ARKANSAS
Department of Environmental Quality

RE: AFIN: 05-00054; NPDES Permit No. AR0034321

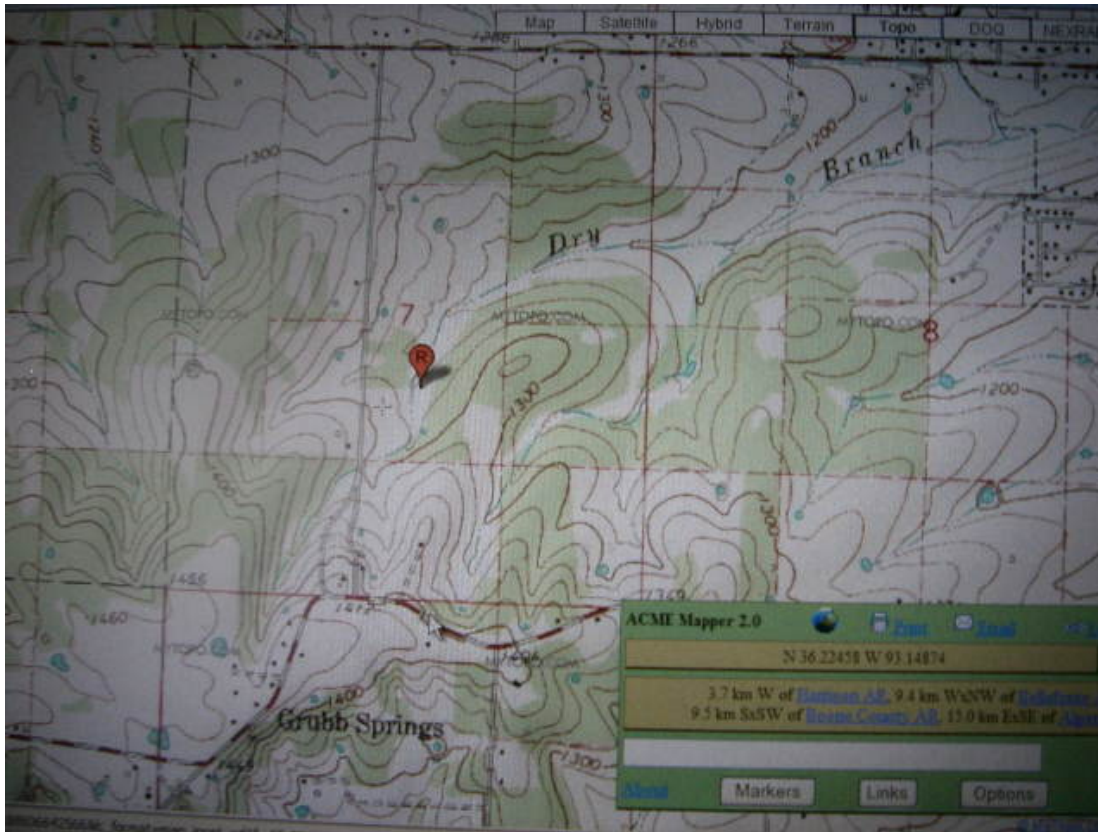
The investigation did reveal that the sewer line and manhole were constructed in soils on the eroding and unstable right-descending bank of Dry Branch and that bank erosion had exposed much of one manhole structure. The Department recommends that the City check on this portion of this sewer line to minimize/prevent any future problems.
